Site: 1385 Hillside Circle, Burlingame, CA

As requested on December 4th, 2023, Kielty Arborist Services visited the above site to provide a Tree Inventory Report/Tree Protection Plan for the proposed construction. 3 new homes are proposed for this site, and your concern as to the future health and safety of the tree has prompted this visit. Preliminary landscape plans L1 through L7 dated January 2024, lot 1 site plans A.1 through A.6 dated 10/26/22, lot 2 site plans A.1 through A.6 dated 10/26/21, and lot 3 plans A.1 through A.8 dated 10/26/21 were also reviewed for writing this report. This Tree Inventory Report is not a Tree Risk Assessment. As such, no trees were assessed for risk in accordance with industry standards, nor are there any tree risk ratings or risk mitigation recommendations provided within this preservation plan.

Showing portion of driveway recommended to be retained until the landscape phase of the project.

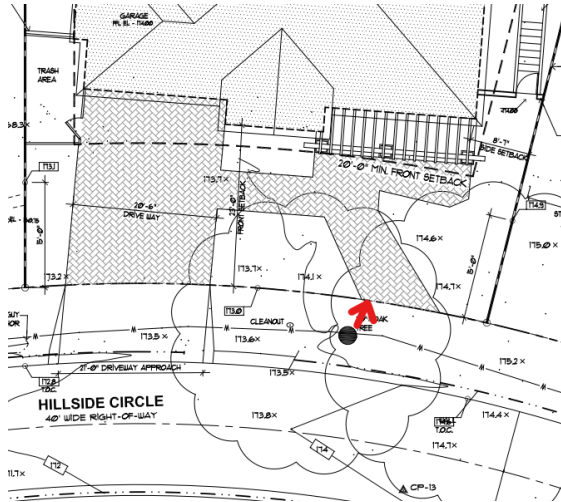
Oak tree #1 is to be retained. The tree is adjacent to an existing driveway. It is recommended to temporarily retain the existing driveway near this tree when underneath the dripline of the tree during the building phase of the project. Temporarily retaining the driveway will act as a tree protection measure and will help to increase staging and access to the site, as removing the driveway at the beginning of the project would make for a larger tree protection zone needed with the fencing being located at the tree's drip line. The existing grade within the tree's dripline is recommended to be retained as is where possible. No grading or excavation is recommended to take place within 10' from this tree (6x diameter) except for the removal of the driveway. At the end of the project, when it is time to demolish the existing driveway near this tree, the Project Arborist is

recommended to be on-site to document and witness the removal of the driveway. A jackhammer is recommended to be used when working within the tree's dripline to break the concrete material into hand manageable-sized pieces. Once broken down the driveway material is recommended to be removed by hand. Exposed roots during the process are recommended to be wrapped in layers of wetted-down burlap to avoid root desiccation. The existing driveway area is recommended to be filled back in once the driveway has been removed so that no roots are exposed to the elements. When backfilling the soil in this area, the area is also to be irrigated. The proposed driveway is further from the tree than the existing driveway and outside of the 10' range and is not expected to have impacts on the tree. The tree is recommended to be deep water fertilized with Nutriroot once the work near the tree has taken place as a mitigation measure for any minor impacts that may take place.

Showing the walkway at 4' from the tree

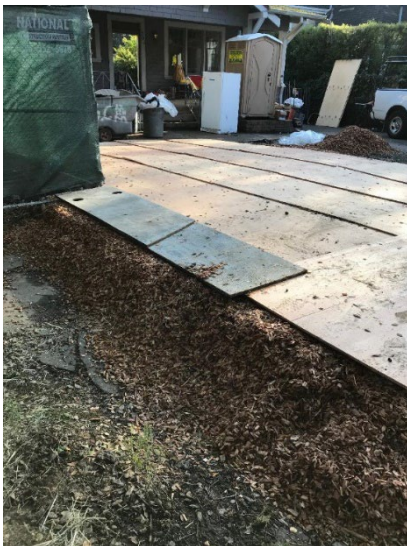
A new pathway is proposed at 4' from oak tree #10. This is too close to the tree and impacts would be expected. It is recommended to maintain a minimal clearance of 10' from the tree to the pathway to keep impacts on the tree low. With this plan change implemented, impacts are expected to be minor and will be mitigated by the recommended deep water fertilizing with Nutriroot.
